MEMORANDUM

RE: Review of the Mitsui E&P USA Hydrogeologic Report, Proposed Water Wells #3 and #4, MEP Pate Property (Freestone County)

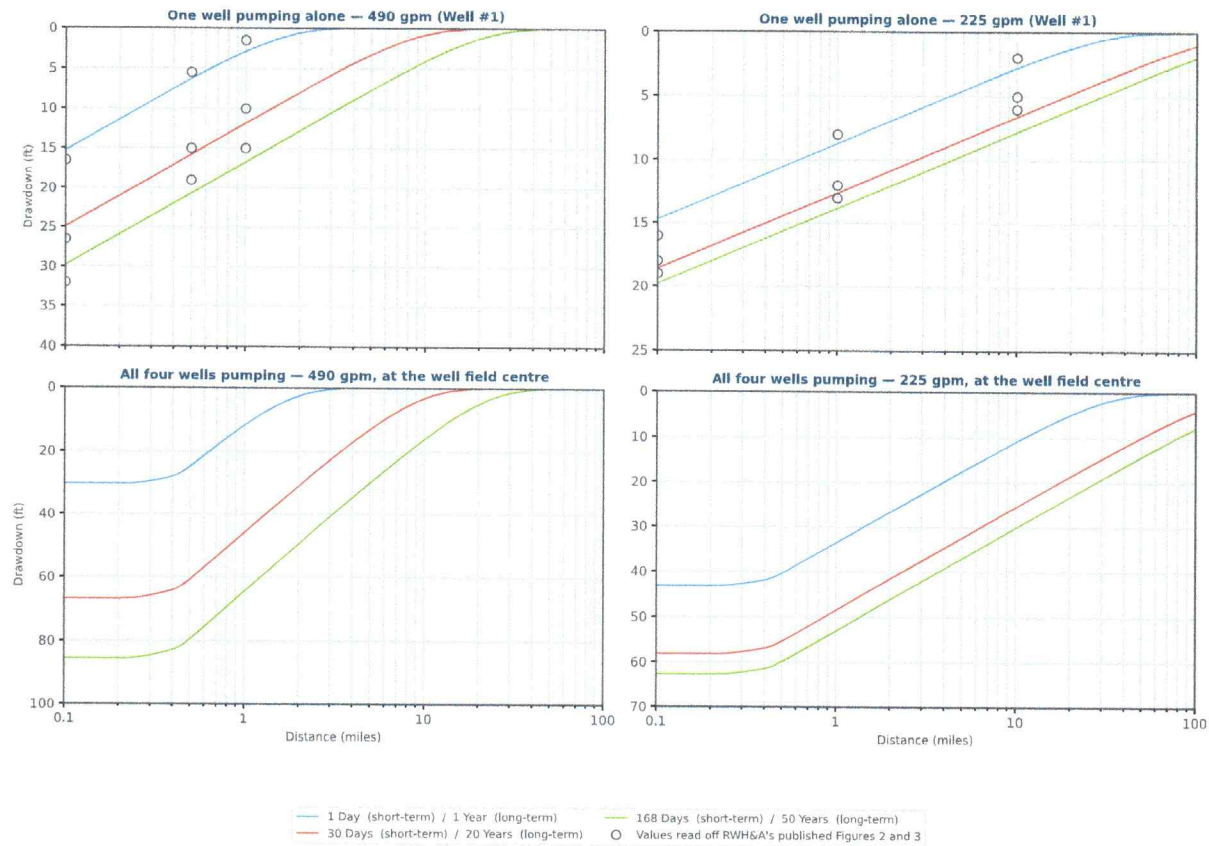
The published figures show single-well drawdown, not the well field. RWH&A's Figures 2 and 3 present one chart per well and, as confirmed above, plot that well pumping in isolation. Their Table 5, by contrast, incorporates interference from all four wells: at off-site well 189471. The report therefore uses two different

conventions without identifying either, and the composite response of the full well field is never presented graphically. Figure 2 of this memorandum shows the difference: over the distances that govern the Area of Influence, the four-well field produces roughly three and a half times the drawdown of the single-well curves that were published.

Conclusions. INTERA finds RWH&A's drawdown calculations to be technically sound and their regional analysis to be correctly performed. The Carrizo beneath the well field will remain fully saturated, with artesian levels projected to stay well above the top of the aquifer over the 50-year evaluation period. We recommend that RWH&A present drawdown-versus-distance curves for the *aggregated* four-well field, and re-derive the Area of Influence from the composite 50-year curve rather than from single-well curves.

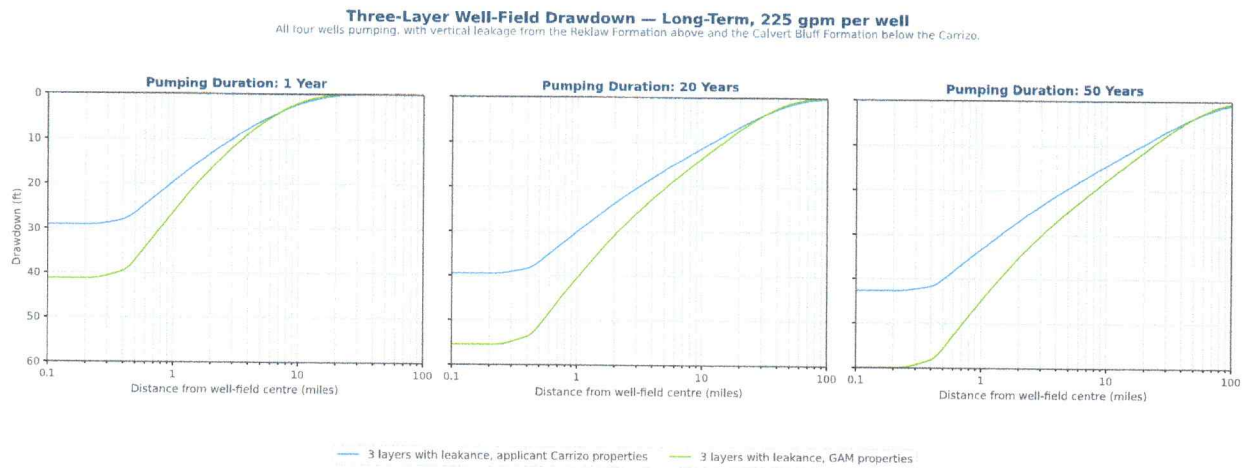
To test the sensitivity of the predicted drawdowns to this assumption, INTERA constructed a three-layer analytic model in TTim comprising the Reklaw (Layer 1, above the Carrizo), the Carrizo (Layer 2, the pumped unit), and the Calvert Bluff (Layer 3, below). Layer thicknesses and properties for the bounding units were taken from the Central Carrizo-Wilcox GAM v3.02 nodes at the site. The model was run twice: once with RWH&A's Carrizo properties and once with GAM-derived Carrizo properties. Results are summarized in Table 3 and Figure 3.

Allowing vertical flow reduces predicted 50-year drawdown at the pumping wells by approximately 26 percent, from 83.5 ft single-layer to 61.5 ft three-layer at Well #1 using RWH&A's Carrizo properties, and at off-site wells by roughly 44 percent. Leakage is negligible over the first day and becomes dominant over decades. RWH&A's single-layer estimates therefore remain a conservative upper bound on drawdown in the Carrizo, which is the protective direction for the District.

Substituting GAM-derived Carrizo properties changes the picture. Transmissivity computed from GAM hydraulic conductivity over the screened interval is 12,394 gal/day/ft, roughly 60 percent of the 20,000 gal/day/ft RWH&A assumed, and predicted drawdown at the pumping wells rises accordingly, to 89.3 feet at Well #1 after 50 years, above both the single-layer and three-layer applicant-property results.

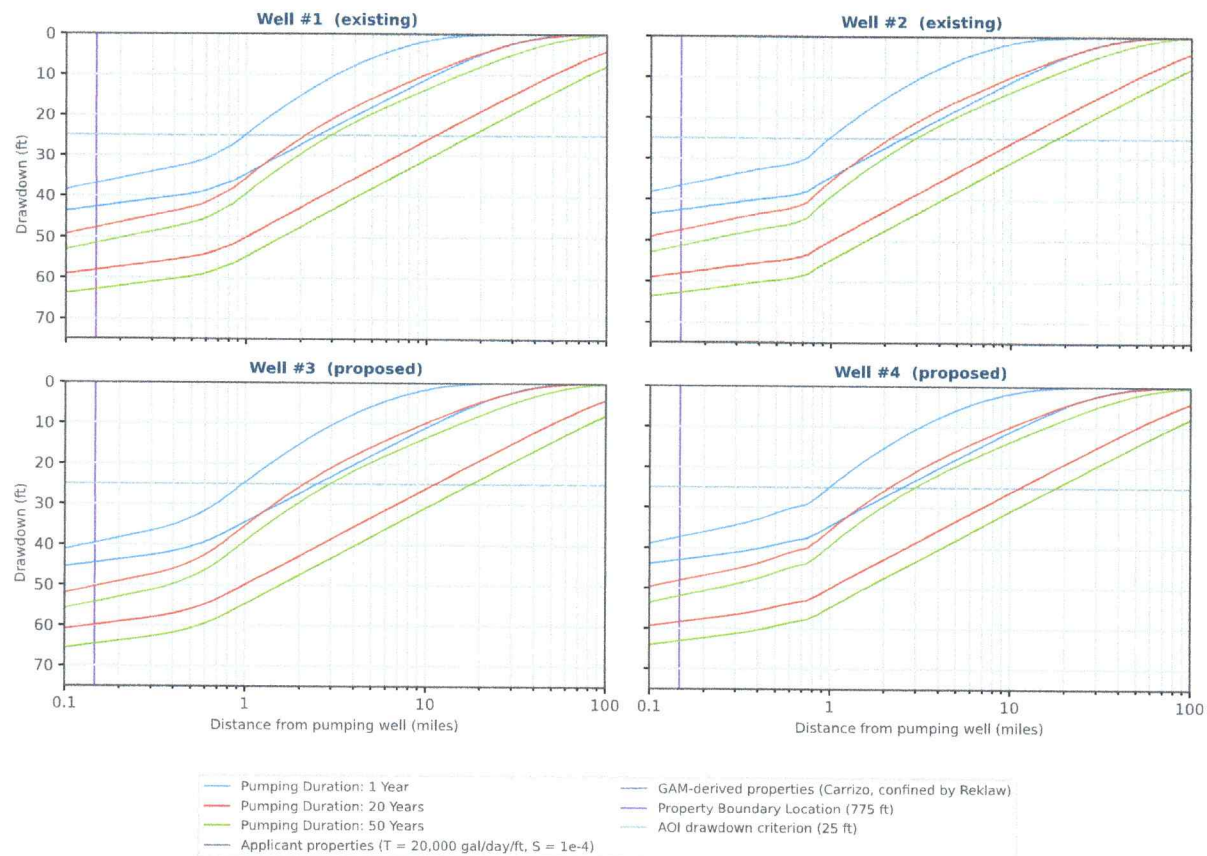
Our results for that radius, computed for the aggregated four-well field with vertical leakage allowed, are given in Table 4. Using RWH&A's Carrizo transmissivity the 25-foot radius is 2.5 miles, consistent with their reported 2.3 miles. Using GAM-derived properties it is 4.8 miles. The applicant's assumed transmissivity approximately halves the Area of Influence.

We do not regard that as a deficiency. RWH&A's transmissivity is site-specific, estimated from static water level and specific capacity data collected at Wells #1 and #2 in May 2026, while the GAM values are regional and calibrated at a 1.38-mile cell scale. For predicting drawdown in the immediate vicinity of the well field the site-specific estimate is the better basis, and we accept it. The District should nonetheless be aware that the AOI is sensitive to this choice, and that a regional-property basis would roughly double the area over which registered wells would need to be identified and evaluated.
